Meeting: 6/16/2021
Applicant: Lori Nash and Ted Stank
Owner: Lori Nash and Ted Stank

Location: 528 W. Glenwood Ave. **Parcel ID** 81 L B 005
Zoning: RN-2 (Single-Family Residential Neighborhood)
District: Oakwood/Lincoln Park Infill Housing Overlay District

6-D-21-IH

APPLICATION FOR CERTIFICATE OF APPROPRIATENESS

Conceptual
Site Plan

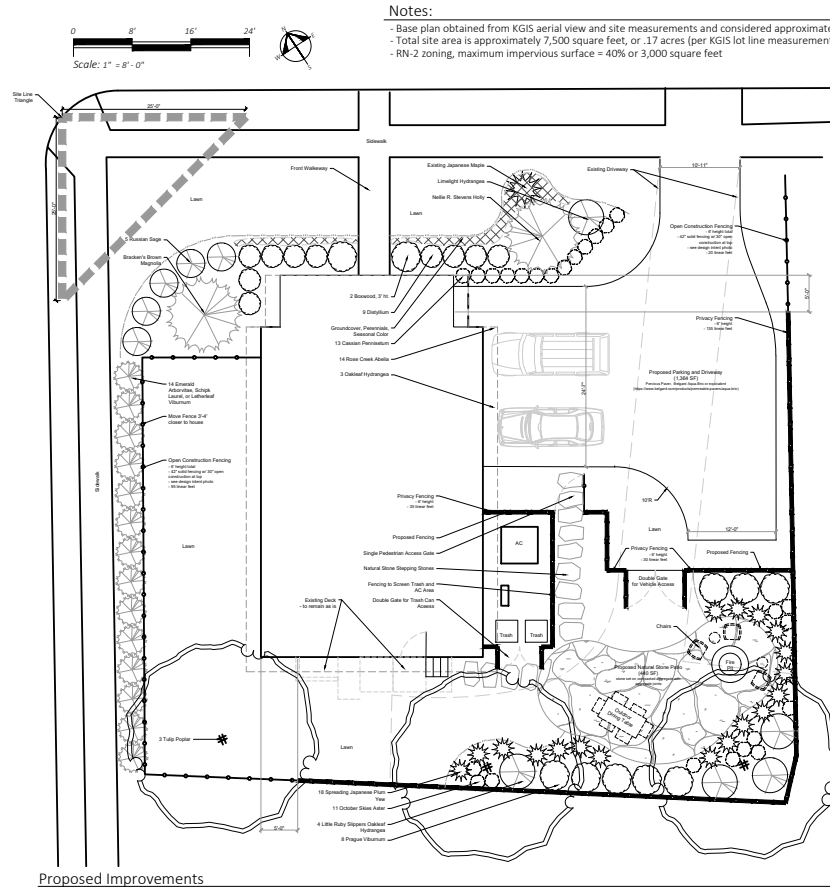
1. The proposed scope of work will remove a significant amount of concrete driveway from the property, replacing the concrete with pervious pavers.
 2. The proposed project does not create a new curb cut or driveway. There is no alley on the property, and the house is located on a corner lot of two relatively busy streets. While the proposed parking area is towards the front of the house (on the right side), it replaces an existing parking area which located the cars in a similar location. The proposed landscaping, including Japanese maples, hydrangea, and holly bushes, will sufficiently screen the parking area from view from the right-of-way. The proposal also includes fencing which will reduce visibility of the new parking pad.
-

3. Several City Engineering requirements exist to be addressed via permitting, including removing the connection to the street and the sidewalk apron on the section of the driveway to be removed from Woodland Avenue, installing pavers on private property only, driveway apron modifications on W. Glenwood Ave, and notes related sidewalks. These items can be addressed on the final site plan for permitting.

Staff recommends approval of Certificate 6-D-21-IH as submitted, with the condition that final site plan meet all City Engineering requirements.
